City of Portland, Maine - Building or Use Permit Application
 389 Congress Street, 04101 Tel: (207) 874-8703, Fax: (207) 874-8716

Permit No: 03-0918	Issue Date: JUL 30 2003	CBL: 195 B014001
-----------------------	-----------------------------------	---------------------

Past Use: single family	Proposed Use: single family - amend permit number 03-0498	Permit Fee:	Cost of Work: \$0.00	CEO District: 3
		FIRE DEPT: <i>N/A</i>	INSPECTION: Use Group: R-3 Type: SB BOCA 99

ADDENDUM TO ORIGINAL FRAMING PRINT FOR RENOVATIONS AT
 60 RIVERVIEW ST PORTLAND, ME URBAN JOB / GERMANI CONST CO.
 City Fax # 874-8716 632-1526

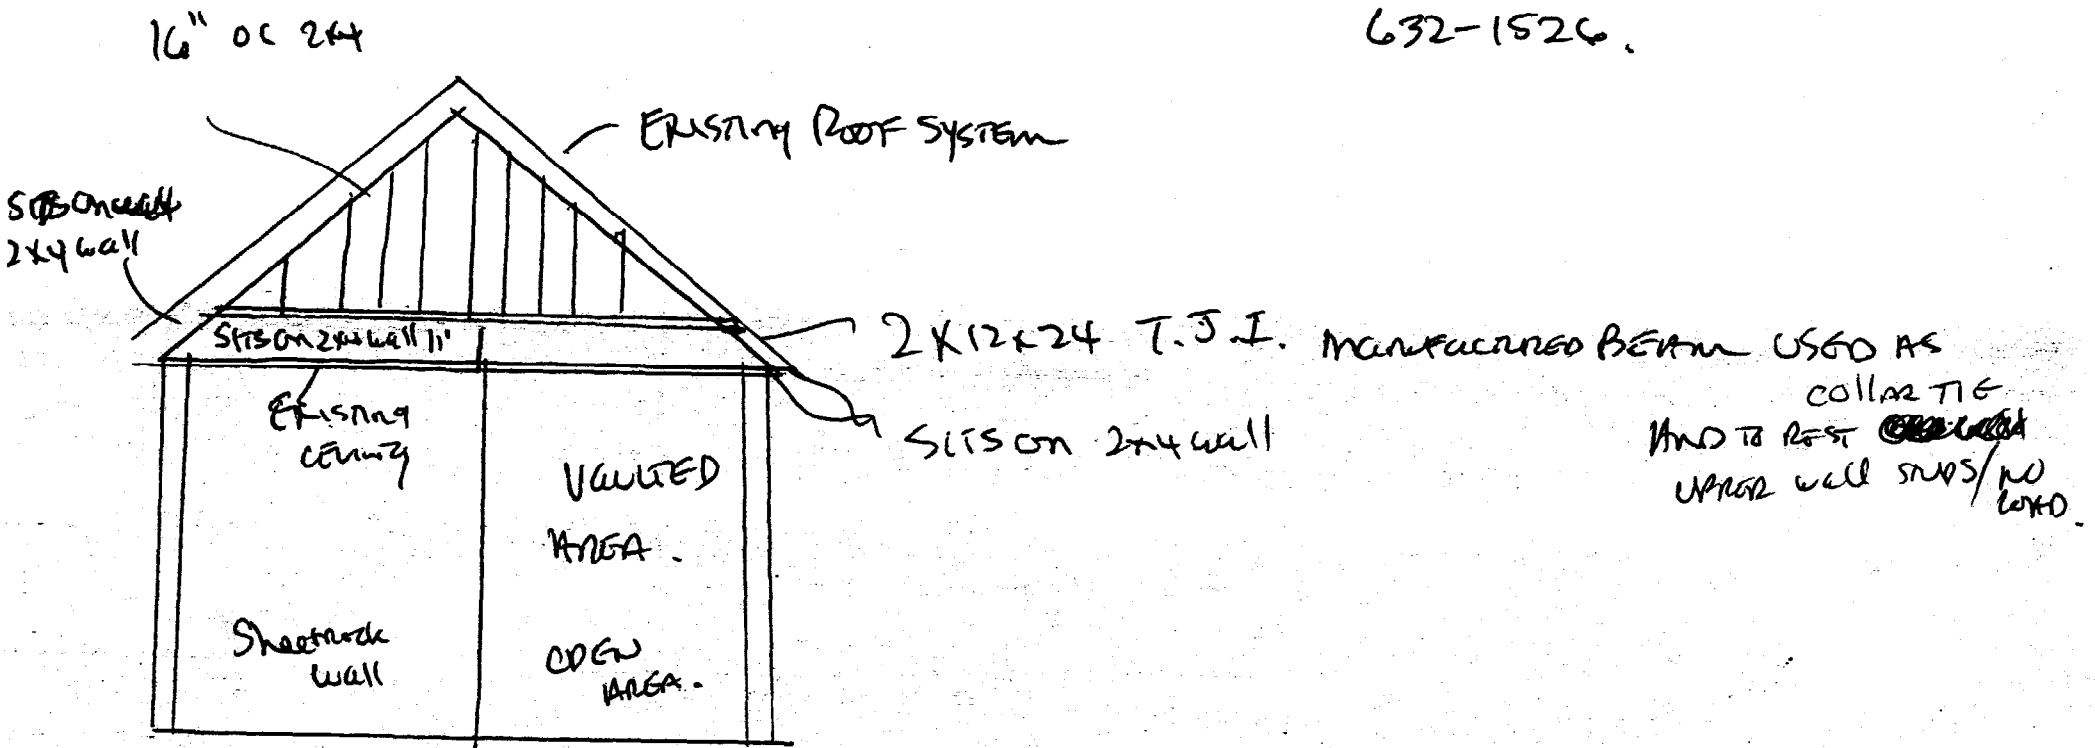
JEANNE - PLEASE ADD THIS TO PRESENT PACKAGE OF PRINTS - CUSTOMERS DECIDED THEY WANTED VAULTED CEILINGS. I SPACED COLLAR TIE / BEAMS EVERY FOUR FEET AT TOP OF WALL HEIGHT. THEY WERE THROUGH BORED W/ FOUR BOLTS 1/2x6 + WASHERS + NUTS THROUGH EVERY THIRD ROOF RAFTER. I ALSO ADDED HURRICANE CLIPS TO ORIGINAL PRINTS. THE RAFTERS ARE ALSO TIED TOGETHER APPROX 5' DOWN FROM RIDGE TO ALLOW FOR VAULTED CEILING WITH 2x4'S. KEVIN WANTED A NEW DRAWING ON THIS CHANGE TO BE ABLE TO ALLOW ME TO CLOSE IN WALL + BEAM AREA. HE ALSO ASKED FOR A SPEC SHEET ON THE 1 T&I. BEAM I USED. THIS BEAM WAS USED TO SEPERATE FLAT CEILING FROM VAULTED. PLEASE SEE BELOW AND FIND ENCLOSED SPEC SHEET FROM MANUFACTURER. I DREW THE ORIGINAL FRAMING PLAN FOR ROOF SO I DREW CHANGES. HOPE THAT IS CORRECT.
